Response to Inspectors Question regarding INQ/131 and Mr Patmore's evidence INQ/132

This note has been prepared in response to questions raised regarding the 'Addendum to Note on Floodplain Compensation Storage provision north of Robertsbridge Station' dated 30th July 2021, which was submitted to provide further information to the 'Note on Floodplain Compensation Storage provision north of Robertsbridge Station' dated 28th July 2021.

This note also provides some further information in response to Mr Patmore's evidence 'Review of Flood Compensation Options (INQ/132) dated 2nd August 2021.

Figure 1 – Existing embankment and indicative rail and ballast levels at Chainage 2970

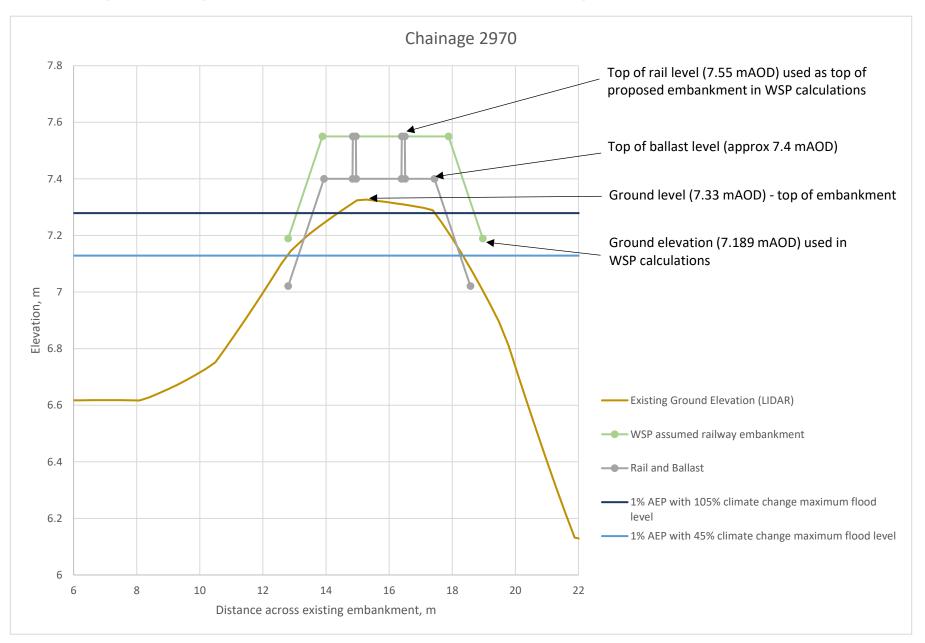
climate change guidance becomes more significant when considering the section between Moat Farm and Junction Road, where there is an existing embankment. Figure 1 illustrates that at some locations a lower maximum flood level reduces the level up to which floodplain compensatory storage is calculated to below the level at which alterations to the existing embankment are proposed.

Table 1 compares the volumes presented in Mr Patmore's evidence to calculations undertaken by Capita using the same method. The Capita calculations have used the latest LIDAR to define ground levels, and the top of the existing embankment east of Moat Farm. As shown in Figure 1 the ground level stated in the Halcrow Gradient Profile drawings as contained in Appendix B1 of OBJ/1002/CP-02, do not capture the top of the existing embankment. This explains the discrepancies between the Capita calculations and the volumes presented in Mr Patmore's evidence.
